27-802 CANFORD SPARE MICROPHONE CAPSULE For DMH220/225, SMH210, headset, 200 ohms

From November 2021 the spare microphone capsule for the Tecpro 200 series headsets and Canford 200 series headsets has changed.

27-802 Mic Capsule - Post Nov 2021

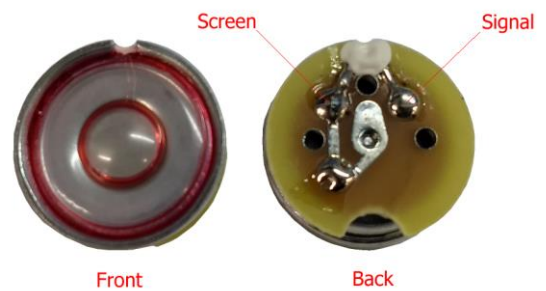
Newer model has the signal and screen contacts on the back of the capsule assembly. Previously contacts were front facing as illustrated below.

Pre Nov 2021 Capsule contacts on the front

Post Nov 2021 Capsule contacts on the back
